REMARKS

This is intended as a full and complete response to the Office Action dated August 31, 2006, having a shortened statutory period for response set to expire on November 30, 2006. In the specification, paragraphs [0018], [0030], [0036] and [0037] have been amended to correct minor editorial problems. In amended Figure 3, Y_2 has been added between lines 350 and 360. Claims 1, 12, 13, 17 and 23 have been amended to more clearly recite various aspects of the invention. Applicants believe no new matter has been introduced by the amendments presented herein. The amendments have been made in a good faith effort to advance prosecution on the merits. Please reconsider the claims pending in the application for reasons discussed below.

FIG. 3

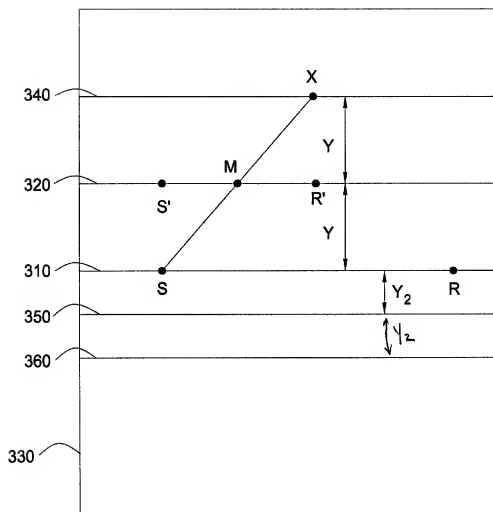
The Examiner objects to Figure 3 for lacking clarity. In particular, the Examiner takes the position that Figure 3 lacks written descriptions for the various depths shown. Further, it is unclear to the Examiner as to which horizontal line represents the water surface and which horizontal lines represent rock interfaces, as opposed to depths at which the source and receivers reside. As explained throughout the specification, the horizontal lines do not represent various depths, water surface or rock interfaces. Figure 3 illustrates a top view of trace (S, R) on target subsurface line (SSL) 310 for which the surface multiples are to be predicted. As such, line 310 represents a target SSL. Line 320 represents an input SSL. See e.g., paragraph [0023]. Line 340 represents a locations-for-X line on which one or more potential downward reflection points are disposed. Line 360 represents yet another locations-for-X line on which one or more potential downward reflection points are disposed. See e.g., paragraphs [0024], [0030] and Figure 2. Line 350

The Examiner objects to Figure 3 because the marker Y_2 should have been drawn between lines 350 and 360. Applicant is grateful to the Examiner for pointing this out. Figure 3 has been amended to add the marker Y_2 between lines 350 and 360. Accordingly, Applicant respectfully requests that the objection be withdrawn.

The Examiner also states that the information on page 9, lines 12-14, which corresponds to paragraph [0024], appears to be inconsistent with the information on paragraph [0030] and Figure 3. Paragraph [0018] has been amended to clarify that Figure 3 illustrates *a top view* of a specific trace on the target SSL 310 for which the surface multiples are to be predicted. The specific trace has a source at S and a receiver at R. See e.g., paragraph [0023]. A point X on a locations-for-X line 340 corresponds to a potential downward reflection point for the surface multiples of trace (S, R). See e.g., paragraph [0024]. Locations-for-X line 340 may contain a plurality of potential downward reflection points X's for the surface multiples of trace (S, R). See e.g., paragraph [0029] and Figure 2. Like locations-for-X line 340, a locations-for-X line 360 may also contain a plurality of potential downward reflection points X's for the surface multiples of trace (S, R). Locations-for-X line 340 is separated from locations-for-X line 360 by $2Y + 2Y_2$ in a crossline direction, where crossline is generally known as a direction perpendicular to the direction of the boat, which may commonly be referred to as the inline direction. See e.g., paragraph [0030] and Figure 3. In view of the amendment and the above explanation, Applicant respectfully requests that the objection be withdrawn.

represents yet another input SSL. See e.g., paragraph [0030]. Accordingly, Applicant respectfully requests that the objection be withdrawn.
